III. Single/Multiple Element Tripping with Protection Violation

PMU Analysis:

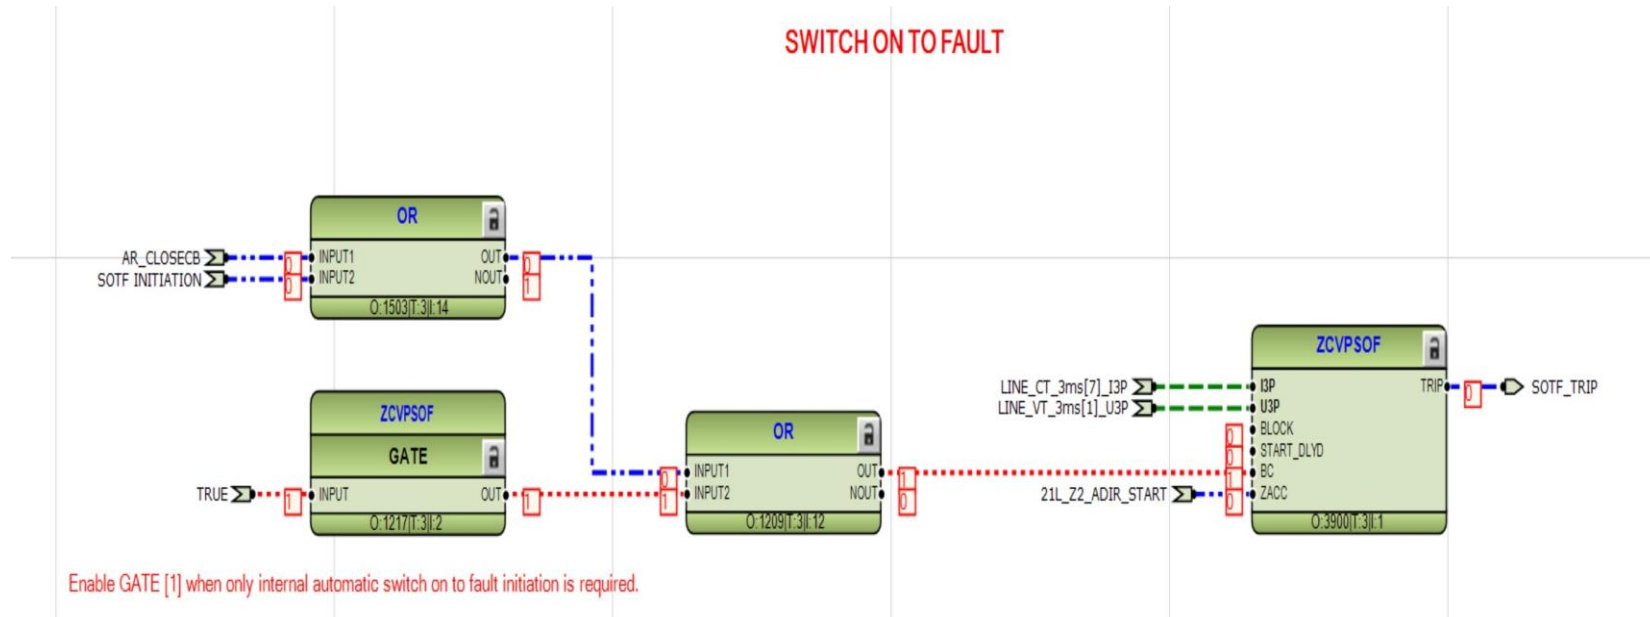
From the PMU plot, B-G fault can be observed without any delayed fault clearance.

1. M/s Greenko informed that, on 05.06.2026 at 20:59 hrs, a B-G fault was sensed and detected under Zone-3 protection at the Greenko CPSS end on the 400 kV Greenko CPSS–Greenko PSP-1 line. Initially, Zone-3 pickup was observed in both Main-1 and Main-2 relays.

2. M/s Greenko further informed that Main-2 relay with the Zone-3 pickup initiated SOTF trip signal after 36 mSec on fault detection resulting in the opening of the circuit breaker in 42 ms.

- ✚ **SOTF may be enabled for the persistent fault during manual breaker closure or initial breaker closure and TOR logic to be enabled for persistent fault on automatic Auto Reclosure**

Before Modification SOTF LOGIC

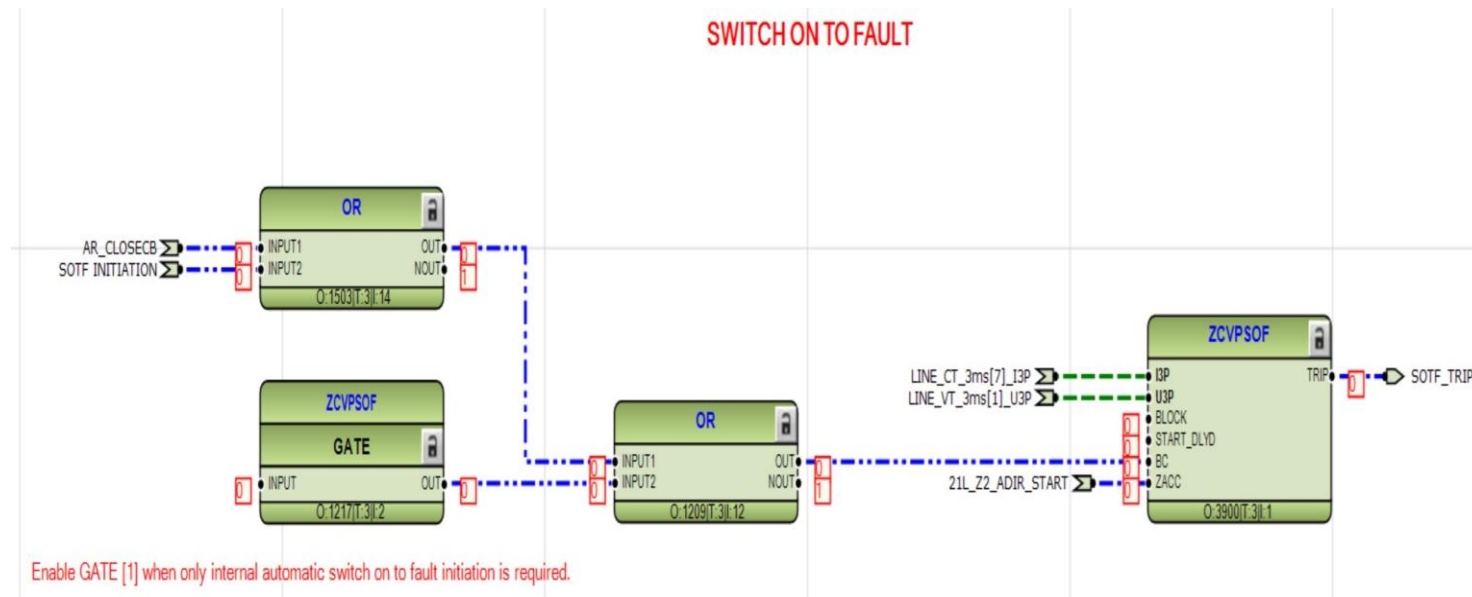
3. Upon detailed investigation, M/s Greenko identified that the SOTF (Switch-On-To-Fault) function logic had been incorrectly configured. A continuous high input signal (Fixed TRUE) was mapped to the SOTF enable input instead of the appropriate SOTF initiation signal.

4. Due to the incorrect logic configuration, the SOTF function remained continuously enabled. Subsequently, during the Zone-3 fault, the SOTF operating conditions were satisfied, resulting in the unintended initiation of the SOTF trip command.

- M/s Greenko informed that the SOTF (Switch-On-To-Fault) logic of Line-1 has been modified to ensure correct operational behaviour. The logic has been configured such that the SOTF function is enabled only during the intended SOTF initiation period.
- Under normal operating conditions, the SOTF function remains disabled and is enabled only upon initiation of Auto-Reclosure (AR), in accordance with the intended protection scheme.
- M/s Greenko further informed that the modified SOTF logic of Line-1 has been aligned with the proven and correctly functioning logic implemented in Line-2.

- M/s Greenko informed that the tripping of Line-1 was due to maloperation of the SOTF function resulting from incorrect logic configuration.
- The identified issue has been rectified by modifying the SOTF logic of Line-1 in accordance with the intended protection scheme and the proven logic of Line-2.
- M/s Greenko confirmed that, following the modification, the SOTF protection logic is functioning as intended.

ANTECEDENT CONDITION

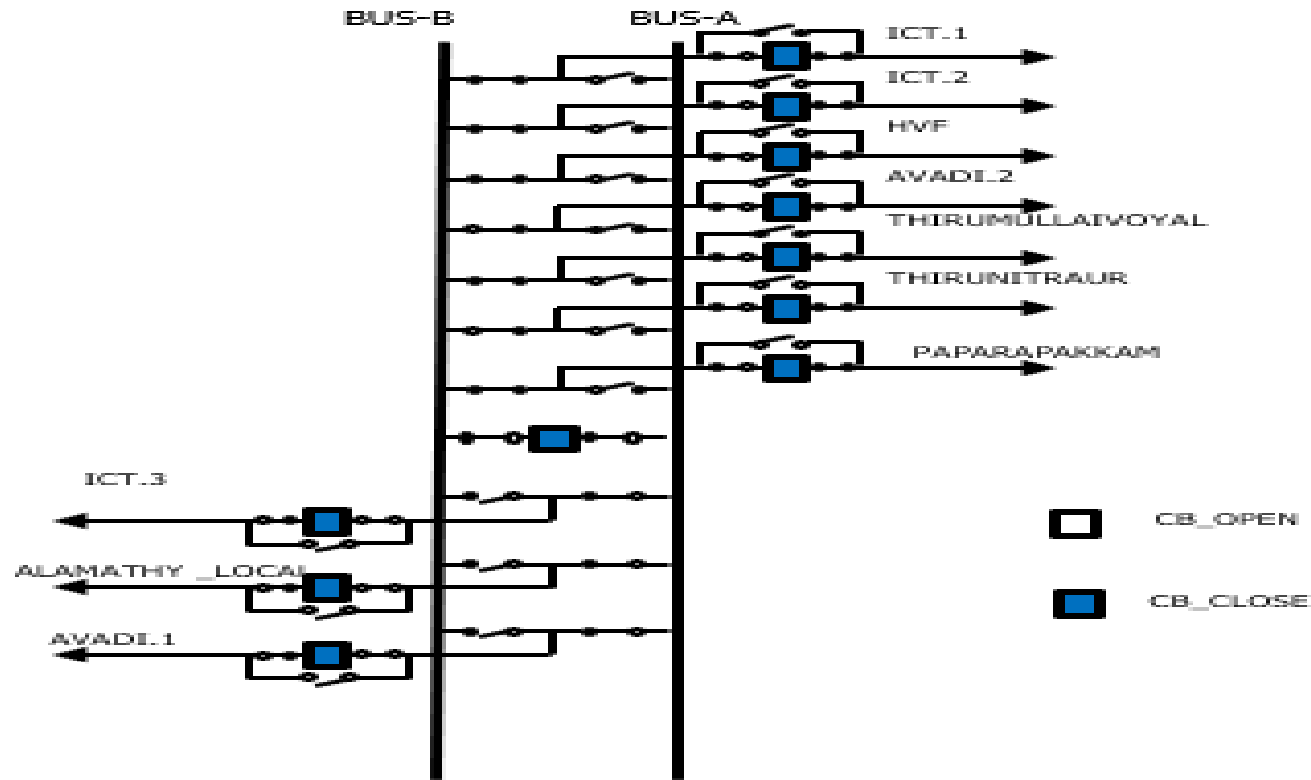
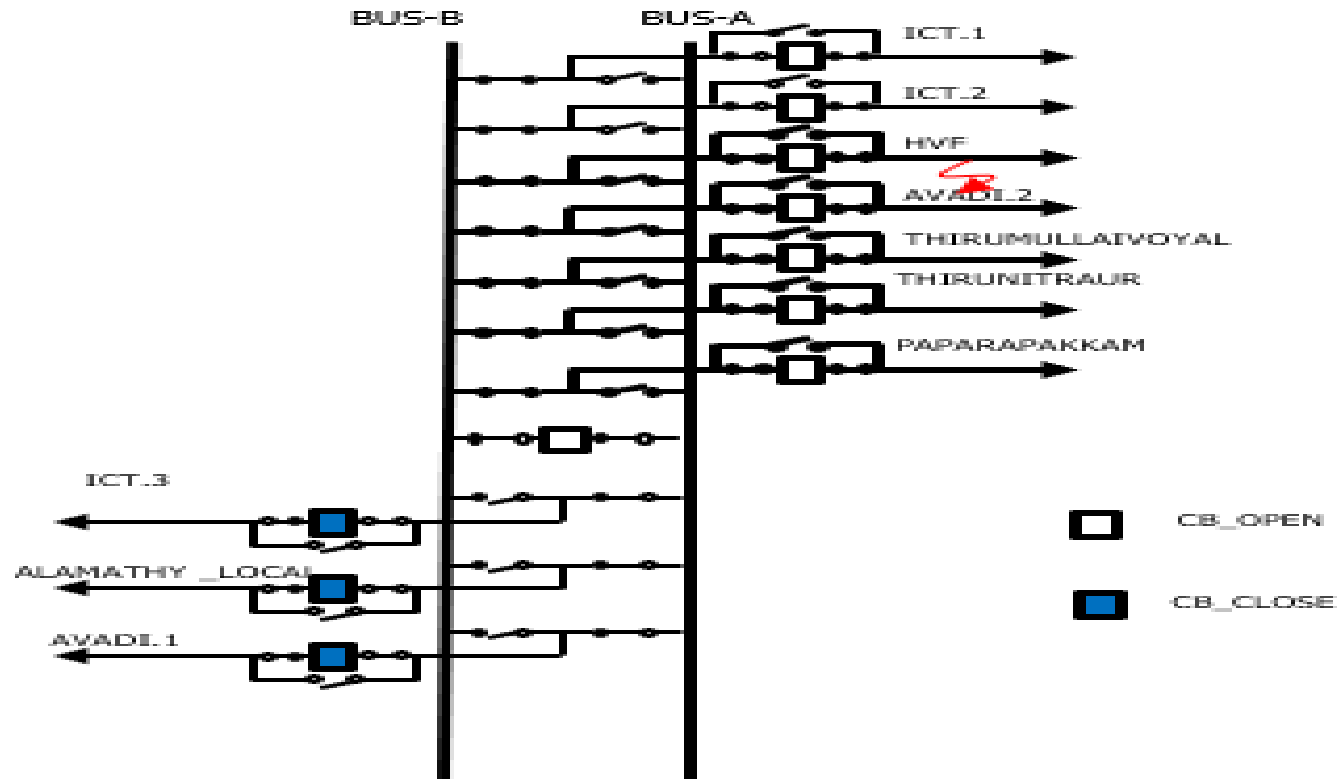
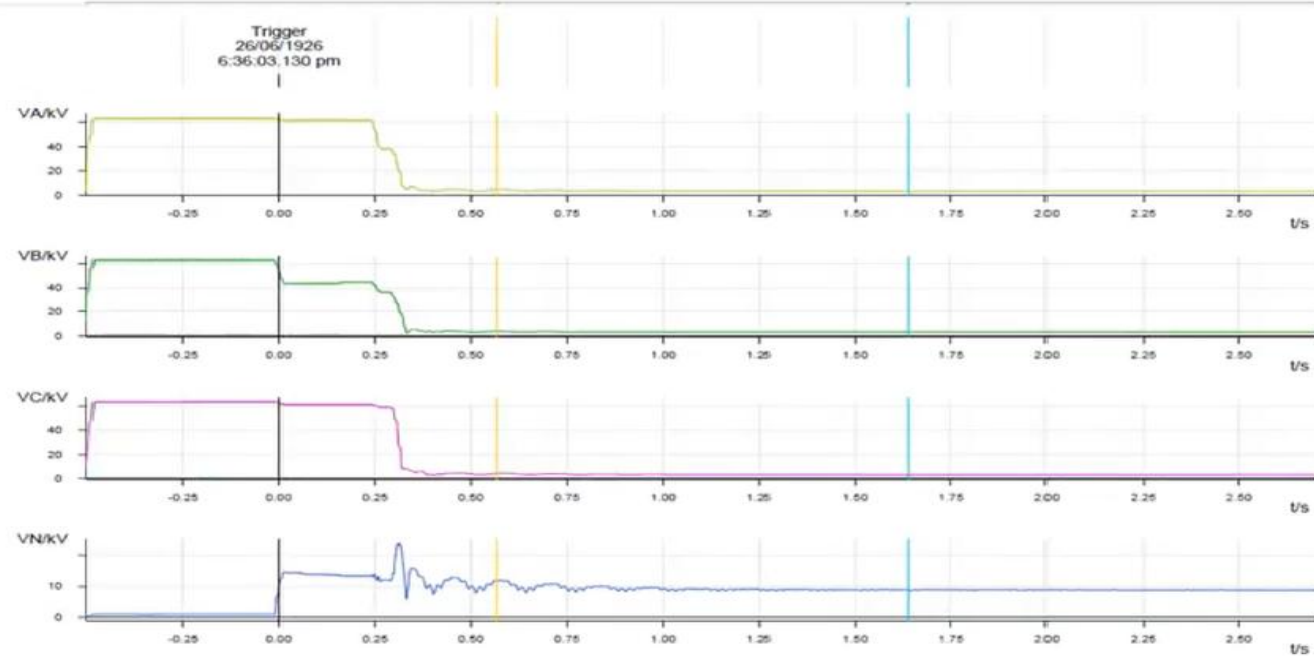
1. Prefault conditions at 400kV Alamthy SS on 26.06.2026 are as follows.
 - Alamathy 400kVSS is having double bus configuration at 110kV Bus
 - Double bus operation was maintained and Bus coupler closed condition.
 - Eight 110kV feeders & 3 ICTs were connected in 110kV Bus.

2. TANTRANSCO informed that the triggering incident is a Y-G fault on 110kV HMF feeder. The feeder breaker failed to isolate the fault and fault current persisted for more than 200ms, hence LBB operated and tripped 400KV/110KV ALAMATHY-ICT-1 and 400KV/110KV ALAMATHY-ICT-2.

3. For a single line to ground in 110kV HVF feeder (shown below), breaker fails to isolate the fault hence LBB protection operated in 110kV Bus B. 110kV Bus A found stable. Load Loss around 104MW

- Line patrol done in 110kV HVF feeder & no visible fault Noticed.
- Breaker operation checked & found Normal.
- Line test charged & stood OK.

7. SRPC advised TANTRANSCO to carry out the periodic maintenance of the Circuit Breakers and associated equipment at 400kV Alamathy SS

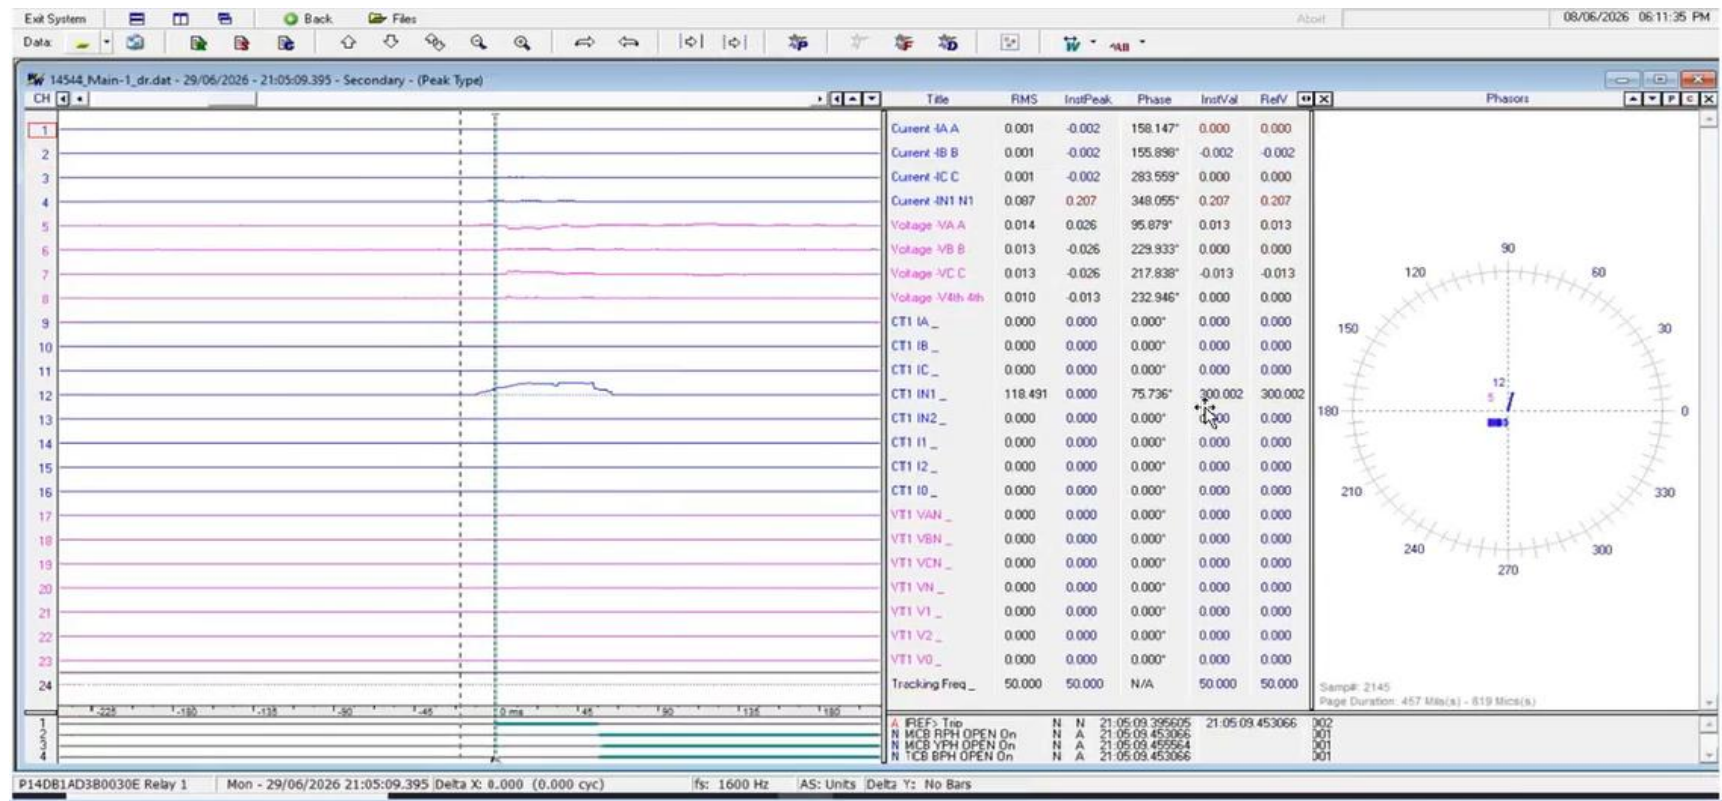
1. TGGENCO informed that, as per the reports submitted, the 400 kV/11.5 kV Yadadri TPP–ST-2 tripped on operation of LV-1 REF protection during an external fault.

2. TGGENCO further informed that LV-1 and LV-2 of the Station Transformer are provided with separate REF protection. During the incident, a heavy through-fault current of approximately 25 kA occurred outside the LV-1 REF zone of ST-2, resulting in the operation of LV-1 REF protection and subsequent tripping of the 400 kV breakers 433-52 and 432-52.

3. TGGENCO suspected that CT saturation during the high through-fault current may have resulted in the maloperation of the Station Transformer REF protection and informed that the matter had been referred to the OEM for detailed analysis.

4. TGGENCO informed that the OEM provided the disturbance recorder (DR) records pertaining to the incident, which indicated that the transformer tripped instantaneously on operation of the REF protection.

5. TGGENCO informed that similar tripping incidents have occurred in other Station Transformers also. TGGENCO further informed that the OEM had recommended modification of the REF protection scheme to prevent inadvertent tripping. In the modified scheme, the neutral CT is connected to an overcurrent element to ensure that the actual neutral current is considered and to prevent maloperation due to CT saturation when the neutral current exceeds 300 A, as observed in the present case.

6. The Forum observed that the REF protection scheme should not be associated with any additional protection element, such as the overcurrent element proposed in the present case. The Forum suggested exploring modification of the stabilizing resistor value to prevent inadvertent operation of the REF protection. TGGENCO informed that attempts had already been made to modify the stabilizing resistor value; however, the inadvertent tripping persisted. Hence, as a last preventive measure, the OEM had recommended modification of the REF protection scheme.

7. The Forum stated that it could not recommend modification of the REF protection scheme. However, TGGENCO may proceed with the OEM's recommendation after due consideration. The Forum further advised TGGENCO to review the scheme and take appropriate

corrective action if inadvertent tripping persists even after implementation of the modified REF protection scheme.

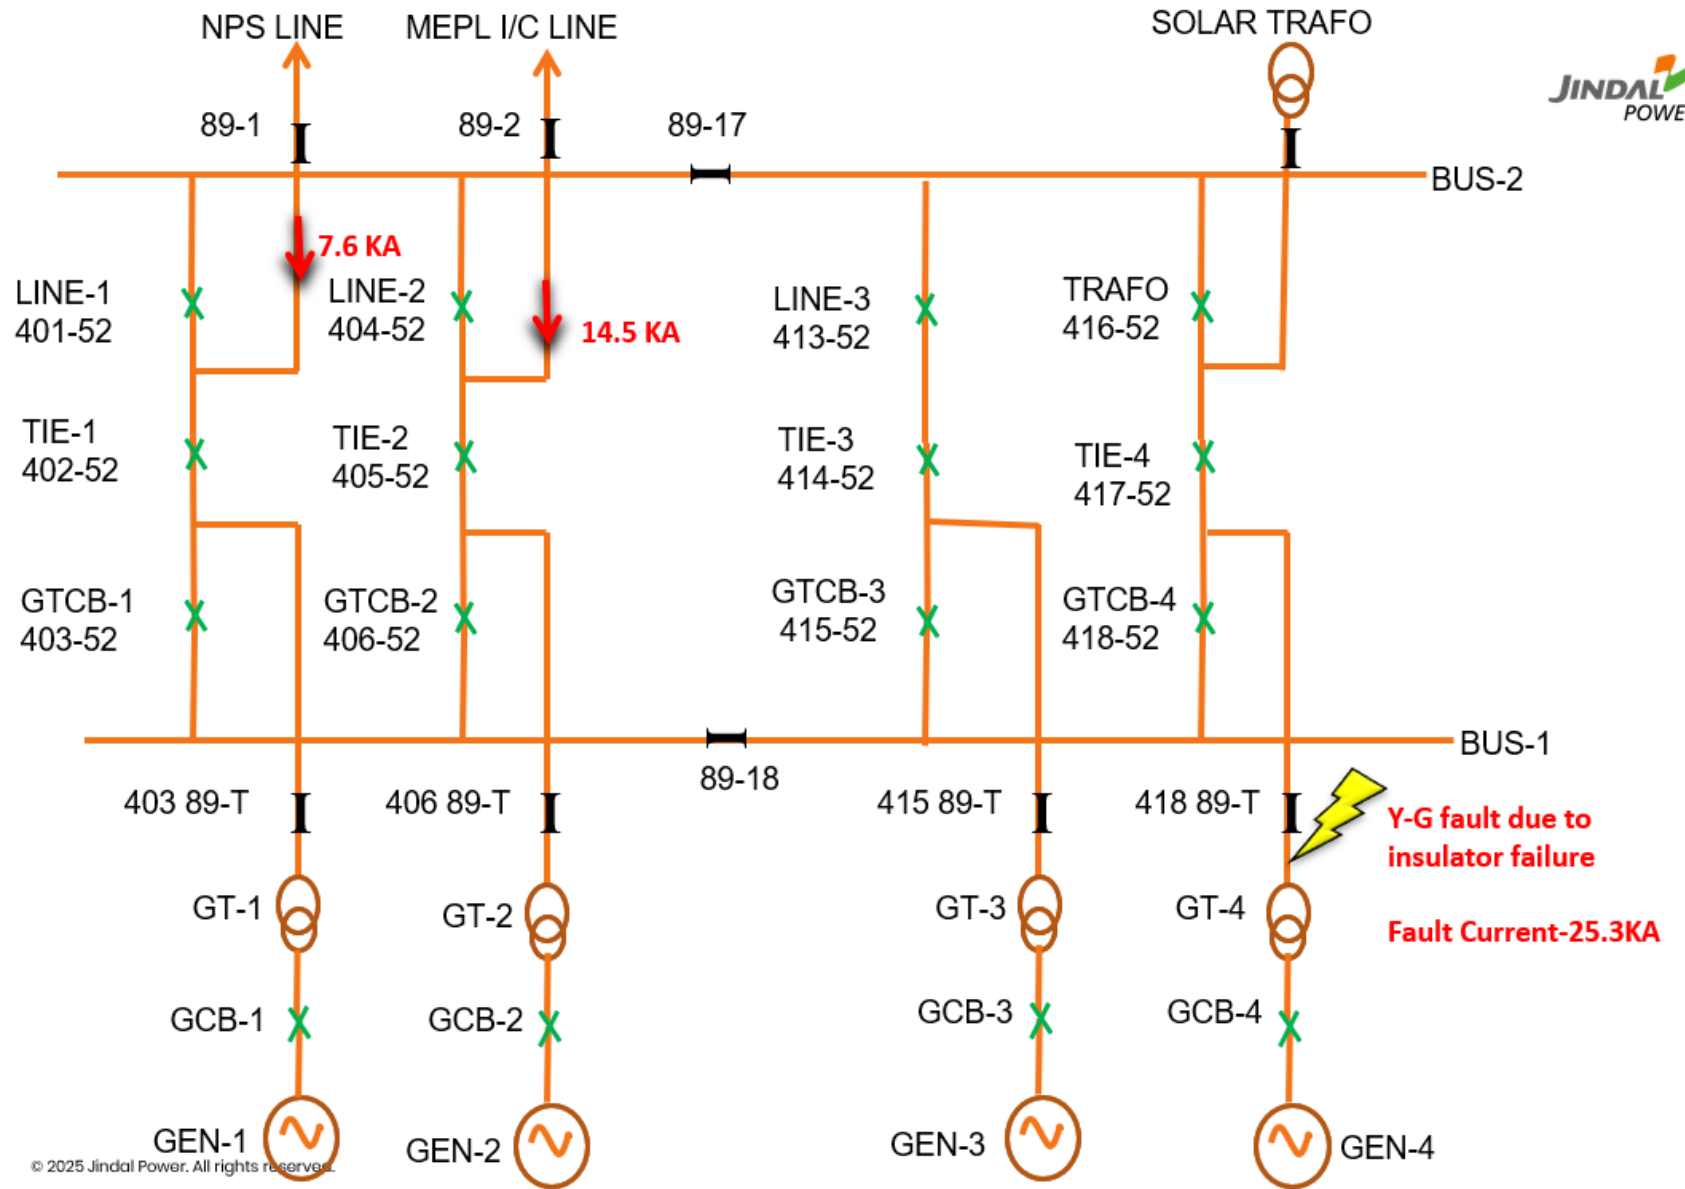
1. SEPL informed that, as per the reports submitted, the triggering incident was a Y-G phase fault due to failure of the Y-phase string insulator of GT-4 at SEPL. The fault was detected by the instantaneous overcurrent (50) protection at SEPL end, resulting in tripping of the SEL–MEPL line, while the line remained in service from the MEPL end.

2. SEPL further informed that the Y-phase string insulator failure of GT-4 resulted in a phase-to-ground fault, with a fault current of approximately 25.3 kA. The fault was cleared by the GT-4 feeder protection within 63 ms. During the fault, a reverse fault current of approximately 14.5 kA flowed through the SEL–MEPL line.

3. SEPL informed that the instantaneous overcurrent (50) pickup setting of the SEL–MEPL line was 12.25 kA. Since the reverse fault current of 14.5 kA exceeded the pickup setting, the instantaneous overcurrent protection operated and resulted in tripping of the SEL–MEPL line.

4. SEPL stated that the SEL–MEPL line tripping was due to the operation of the instantaneous overcurrent (50) protection caused by the high reverse fault current associated with the external Y-G fault at GT-4.

5. SEPL informed that all porcelain-type insulators had been replaced with polymer insulators except those installed in the GT-4 row and Line-1 & Line-2. Following the incident, SEPL replaced the porcelain insulators in the GT-4 row and informed that replacement of the insulators in Line-1 & Line-2 is also planned.

6. SRLDC advised SEPL to disable the definite-time overcurrent and instantaneous overcurrent protection functions provided on both 400 kV lines. SEPL informed that, since the 400 kV MEPL–SEPL Line-1 is only approximately 900 m in length, line differential protection has been provided as the primary protection, with overcurrent protection provided as backup protection.

7. SEPL was informed that distance protection should be provided as the backup protection for short lines with line differential protection. Accordingly, SRLDC advised SEPL to enable distance protection as backup protection for the line differential protection on both 400 kV lines. SEPL agreed to implement the same.

- ✚ SEPL to provide distance protection as backup protection for the both 400 kV MEPL-SEPL short lines along with the primary line differential protection.
